D14 Academic Building

**Access Report
prepared for UNSW
Sydney
Final v2**

8 November 2018

Figure 1: Extract (not-to-scale) from drawing ADDA00001. North is up the page, and High Street runs from left to right at the very top of the image.

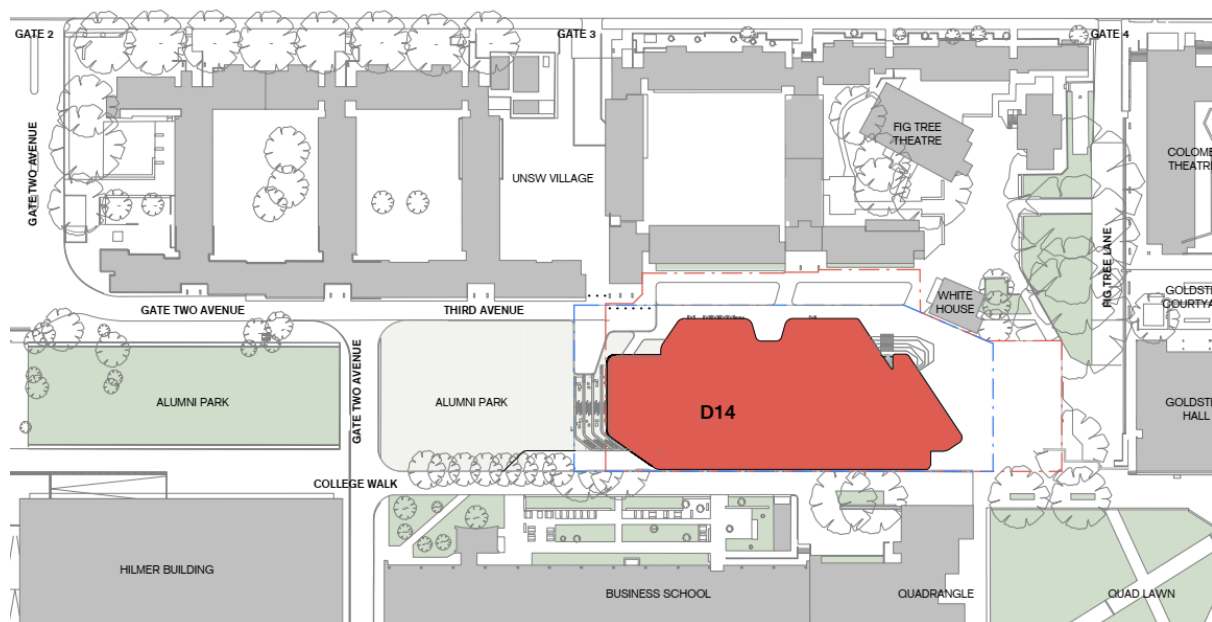
The allotment boundary of the Kensington campus of UNSW is located on the existing public roadway of High Street, which runs in an east-west alignment. The subject building will be offset a distance of some 80 metres from High Street. The existing Fig Tree Lane runs on-grade from High Street in a north-south alignment through the Kensington campus to the site of the subject building.

The project will include a new section of footpath that will run parallel to Third Avenue. The new section will run in an east-west alignment along the northern edge of the subject building. The new section will be capable of providing an accessible path of travel within the meaning of AS1428.1(2009) from the existing Fig Tree Lane to the various new building main entrances on the northern façade of the subject building for compliance with the DDA Access Code 2010 and BCA.

Figure 2: Extract (not-to-scale) from drawing ADDA20000. North is up the page.

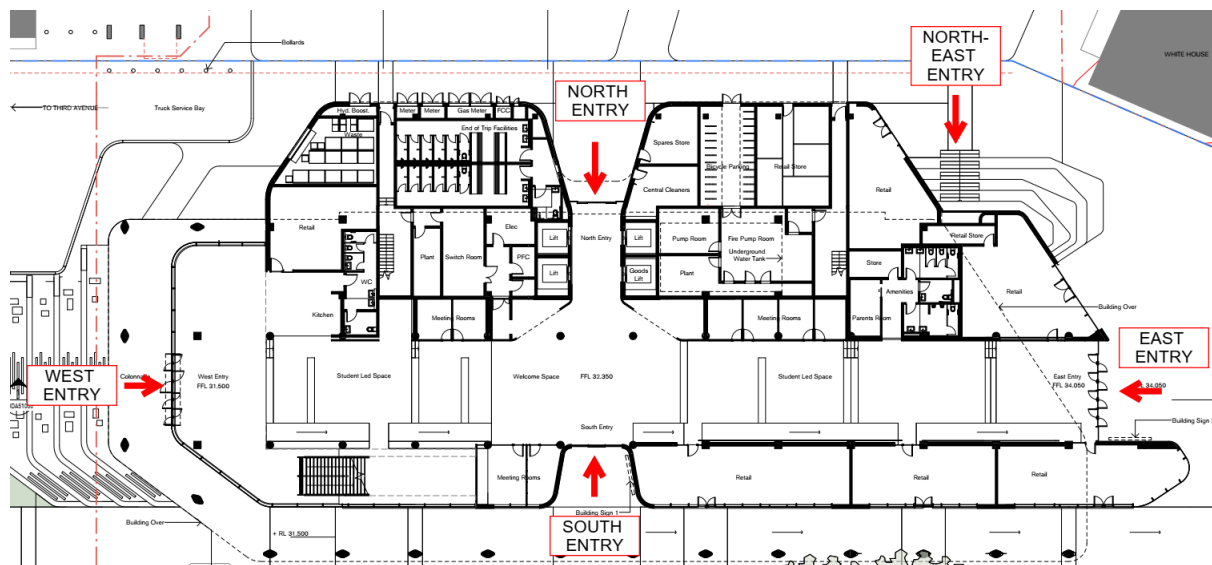
There will be a total of five new pedestrian main entrances on Ground Level that will be for the common use of the Class 9b and Class 5 areas. Those five main entrances are annotated with red arrows in plan in Figure 2 below:

Of the main entrances, four will be on-grade doorways that will be designed to be accessible within the meaning of AS1428.1(2009) – namely, the north entrance, the south entrance, the east entrance, and the west entrance. As discussed previously under ‘External Linkages’ in this report, there will also direct accessible paths of travel respectively from Third Avenue, College Walk, and Fig Tree Lane to each of the above four accessible main entry doorways for compliance with DDA Access Code 2010 / BCA.

In addition to the four accessible, on-grade main entrances, there will be one external main entry stairway in the north-east sector of the subject building that runs from Ground Level to Level 1. A stairway-only main entry is not deemed to be ‘accessible’.

Even so, the provision, of four accessible main entrances out of total of five main entrances is permissible under the DDA Access Code 2010 / BCA. In addition, the main entry stairway will be located at a distance of less than 50 metres from two of the accessible main entrances on Ground Level – namely, the north and east entrances. This is a permissible arrangement under the DDA Access Code 2010 and BCA. In totality, the designation of accessible and non-accessible main entrances will be suitable for compliance with the DDA Access Code 2010 and BCA.

It is to be noted that the main entry stairway will be a non-fire-isolated stairway. As a non-fire-isolated stairway it would, under the DDA Access Code 2010 and BCA, require AS1428.1 features. This would include handrails. This will be addressed during design development stage.
